Project	<b>IEEE 802.16 Broadband Wireless Access Working Group</b> < <a href="http://ieee802.org/16">http://ieee802.org/16</a> >	
Title	<b>Additions to 802.16 Packing Function</b>	
Date Submitted	<b>2001-03-06</b>	
Source(s)	Vladimir Yanover BreezeCOM Atidim Technology Park Bldg. 1 P.O. Box 13139 Tel-Aviv Israel	Voice: +972-36457834 Fax: +972-3646222 <a href="mailto:vladimiry@breezecom.co.il">mailto:vladimiry@breezecom.co.il</a>
Re:	This document is submitted in response to 802.16 Letter Ballot #3	
Abstract	Two additions for the 802.16 MAC packing function are proposed	
Purpose	The author wants 802.16 to consider this document within a process of comments resolution for the document IEEE 802.16 / D2-2001	
Notice	This document has been prepared to assist IEEE 802.16. It is offered as a basis for discussion and is not binding on the contributing individual(s) or organization(s). The material in this document is subject to change in form and content after further study. The contributor(s) reserve(s) the right to add, amend or withdraw material contained herein.

# **Additions to 802.16 Packing Function**

**Figure XX. The Partial Payload with Packing Header and Address Field**

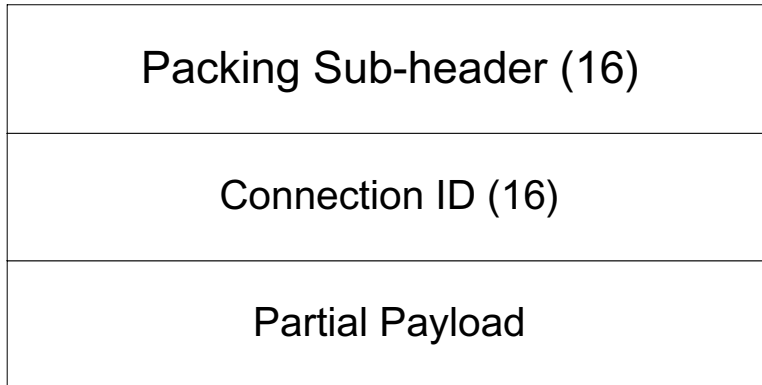
### **3.2.3. Page 104, Line 51, Section 6.2.3.3.2**

Add the following text and the picture

If the Partial Payload Addressing Indicator (see 6.1.1.1.2) is ON then the address field should be added to the partial payload. The address field contains Connection ID
